# Nomad

# SERVICE BULLETIN

## FORWARD CABIN WINDOWS – IMPACT RESISTANT TRANSPARENCIES – MOD N452

Figure 1 Templates for Manufacture of Cabin Window Gasket

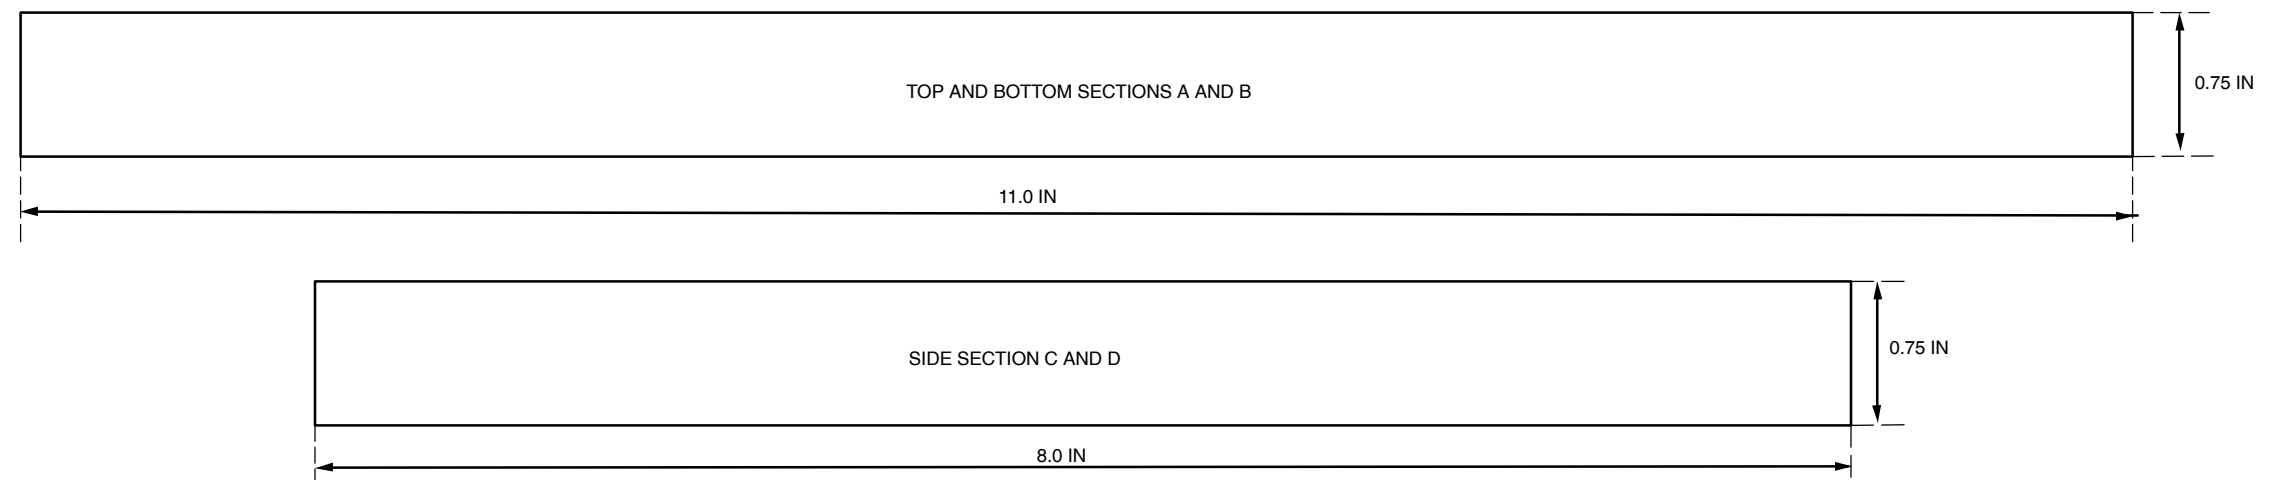
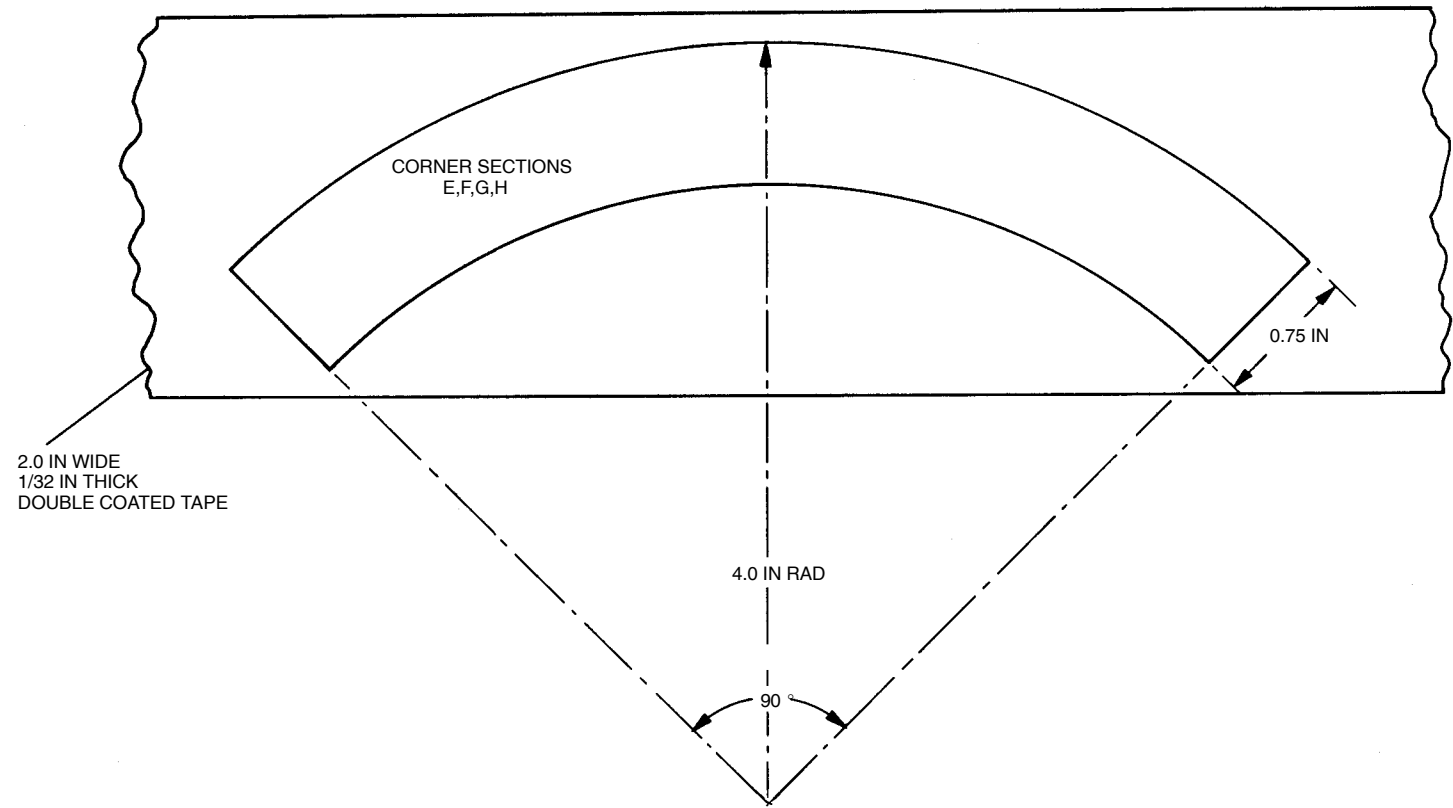
Double sided adhesive gaskets are manufactured from PN 4032 Scotchmount double coated adhesive tape 2 inches wide and 1/32 inch thick using the templates in Figure 1.

NOTE: MANUFACTURE ALL SECTIONS FROM  
MMM'S SCOTCHMOUNT DOUBLE COATED  
TAPE 4032

**Figure 2 Window Installation**

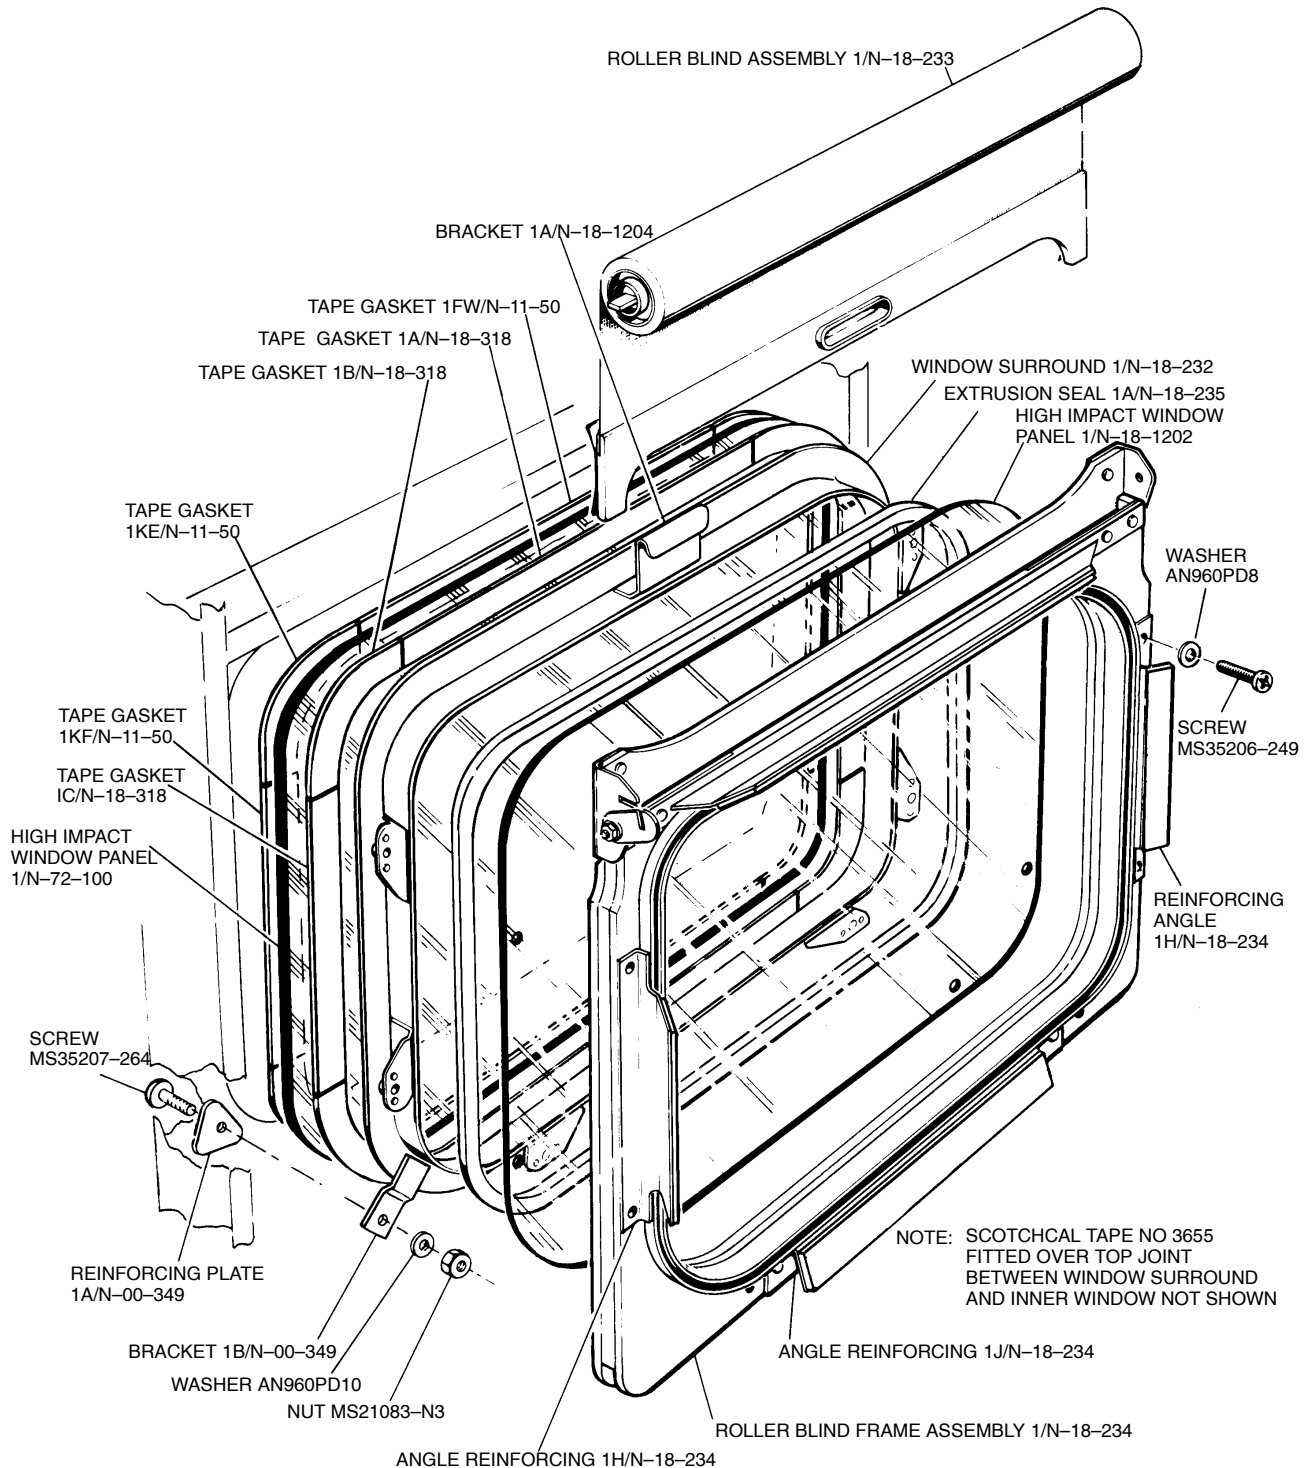
N24-Series aircraft have the forward cabin windows in line with the plane of rotation of the propellers. An incident has occurred in which ice, shed from a propeller, broke the adjacent forward cabin window and entered the cabin.

The forward outer and inner passenger cabin windows at Sta 150.0 are replaced by windows made of 0.125 inch thick, clear high impact resistant polycarbonate material.

#### B. Install the High Impact Polycarbonate Windows (Ref Figure 2)

- (5) Remove the protective paper from the other side of the gaskets, align the new high impact polycarbonate outer window panel with the position marks on the inner surface of the fuselage skin and apply firm pressure around the edges of the window panel and the window aperture to ensure satisfactory adhesion of the window panel to the fuselage skin.
- (6) Apply a fillet of PR1221B or PR1222B sealing compound around the external joint between the fuselage skin and the outer window panel. The fillet is not to extend more than 1/16 inch beyond the edge of the skin onto the window panel.

- (7) Clean the internal surface of the outer window panel.
- (8) Secure the window surround to the outer window panel by removing the protective paper from one side of the double sided adhesive gaskets and pressing them firmly in position on the outer face of the window surround. Remove the protective paper from the other side of the adhesive gaskets and then press the window surround firmly into position on the outer window panel, ensuring that good adhesion is obtained. Using the brackets, new screws, washers and new self-locking nuts (Ref Service Bulletin NMD-56-4), secure the window surround and the outer window panel to the fuselage skin. Torque tighten the self-locking nuts to between 12 and 15 pound inches.

- (10) Assemble the replacement inner window panel to the roller blind frame so that the six holes in the inner window panel align with those in the roller blind frame assembly. Position the complete assembly to the window surround.
